FIRE SAFETY INSPECTION REPORT

Factory Name: REMI HOLDINGS LIMITED

Date: 22 June, 2016.

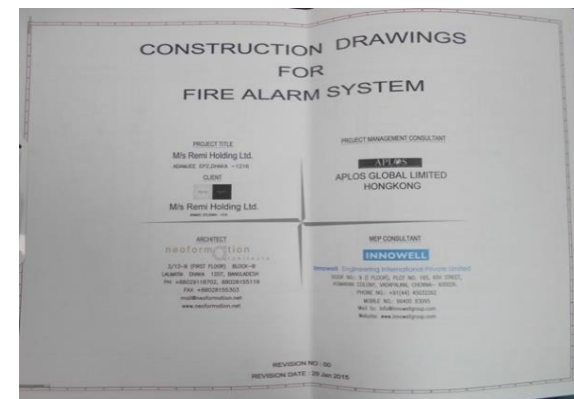
2	Fire Rated Construction	Rooms used for storage of combustible materials are not separated from the surrounding occupancy/areas	Rooms used for storage of combustible materials shall be separated from the surrounding occupancy with a minimum 1 hour construction.
---	-------------------------	--	---

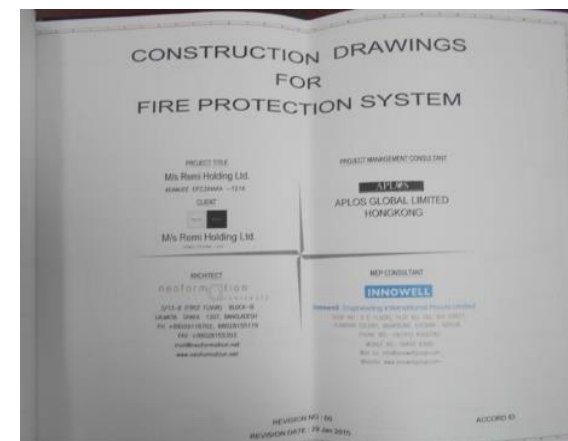
| 5 | Fire Alarm & Detection System | The addressable fire alarm system installation is going on without approval from AHJ. | Submit As-Built drawing to AHJ for approval and replace or modify the fire alarm system in accordance with NFPA 72. | Within 2 months (Design submission) & 6 months (Installation) |
